# Access Compliance Report

## Public Rights-of-Way

### (Curb Ramps)

Intersection ID: 28233	Main Street: DARBY_CHASE_DR	Cross Street: N/A	Location: NE
ADA ID: 1778D5222A8A	Ramp Type: Perp	Initial Pass/Fail: Fail	Overall Compliance: No
Severity Score: 47.5			
Codes/Mitigation Info/Possible Solution		Field Measurements/Component Compliance

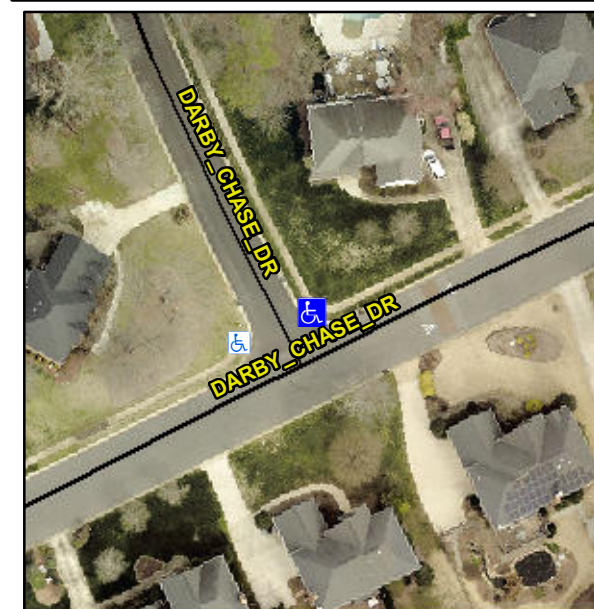
**Not Found, R304.5.1, R304.5.3**

Compliance	Description	Data	Compliance	Description	Data
N/A	Ramp Length (in)	94.0	Yes	Ramp Slope (%)	5.0
No	Ramp Width (in)	25.5	No	Ramp XSlope (%)	5.1
N/A	Flare Type LT	N/A	N/A	Flare Type RT	N/A
N/A	Flare Slope LT (%)	N/A	N/A	Flare Slope RT (%)	N/A
N/A	Flare Traversable LT?	N/A	N/A	Flare Traversable RT?	N/A
N/A	Landing Length (in)	N/A	N/A	DWS Provided?	N/A
N/A	Landing Width (in)	N/A	N/A	DWS Contrast?	N/A
N/A	Landing Slope (%)	N/A	N/A	DWS Length (in)	N/A
N/A	Landing X Slope (%)	N/A	N/A	DWS Full Width?	N/A
N/A	Landing Curb? (Y/N)	N/A	N/A	DWS Offset (in)	N/A
N/A	Shared Landing?	N/A			
N/A	Gutter Ponding?	N/A	N/A	Gutter Slope (%)	N/A
N/A	Gutter Lip Ht (in)	N/A	N/A	Gutter X Slope (%)	N/A
N/A	Painted X Walk1?	No	N/A	Painted X Walk2?	N/A
	X Walk 1 Direction	To SW		X Walk 2 Direction	N/A
N/A	X Walk 1 Width (in)	N/A	N/A	X Walk 2 Width (in)	N/A
	X Walk 1 Slope (%)	2.7		X Walk 2 Slope (%)	N/A
	X Walk 1 X Slope (%)	0.9		X Walk 2 X Slope (%)	N/A

**Remove & Replace Entire Ramp.**
